54-097 SAS01T to SAS03T Replacement Information

TSB-54-097-WST

Creation Date: 2025-02-04

- ▶ 47X
- ▶ 49X
- ▶ 57X

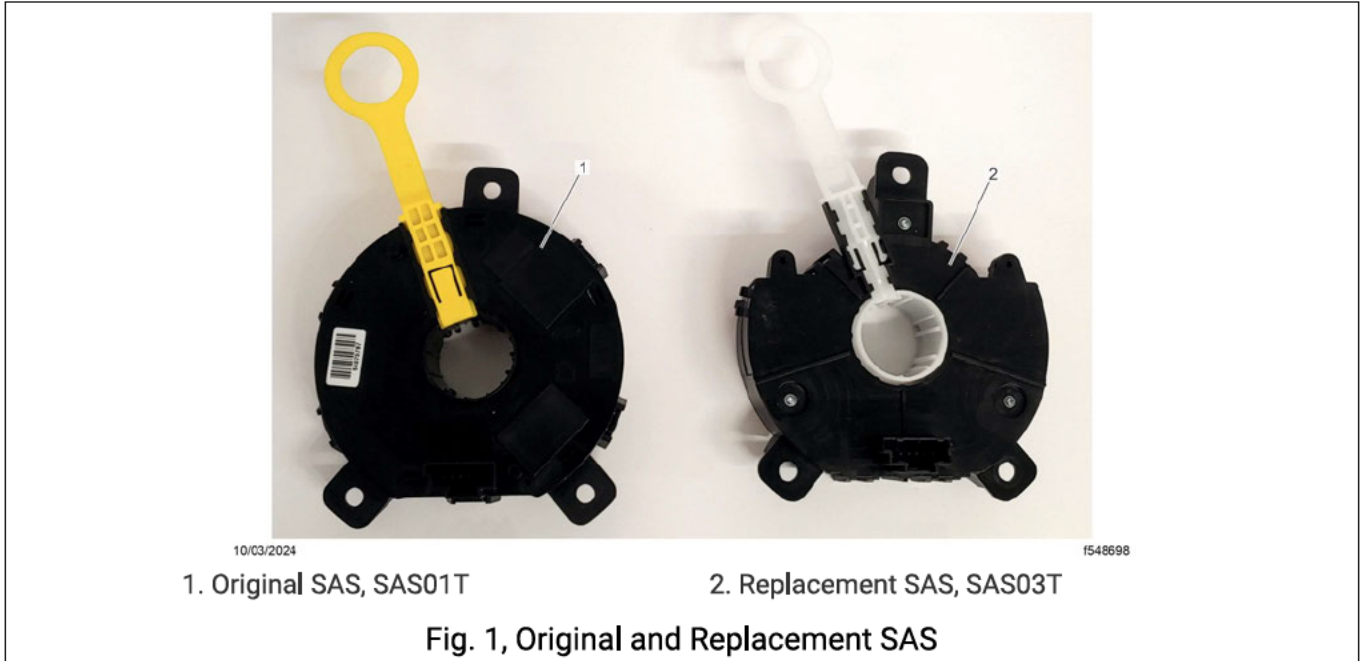
When the Steering Angle Sensor (SAS) model SAS01T runs out of stock, it is substituted with the SAS03T model. The SAS03T is designed to be mounted in the same manner as the SAS01T. However, depending on the software package of the vehicle, changing from SAS01T to SAS03T could result in the activation of fault code 'SA 23 SPN 523021/FMI 31 - The list of Electronic Control Units (ECUs) stored in the Warning Database (WDB) does not match the list of ECUs parameterized in PID 0x20.' Due to the possibility of the fault code being activated, the parts listed in Table 1 cannot be directly superseded.

The SAS03T appears slightly different compared to the SAS01T as shown in Fig. 1. However, the process of replacing and mounting the SAS remains the same. For instructions, see **Group 20** of the applicable workshop manual.

When replacing the original SAS01T, see Table 1 to find the new replacement part SAS03T.

Chassis CAN Baud Rate	Original Part Number (SAS01T)	Replacement Part Number (SAS03T)
500kb Chassis CAN	A14-19418-000	A14-21040-307
667kb Chassis CAN	A14-20044-000	A14-21040-106
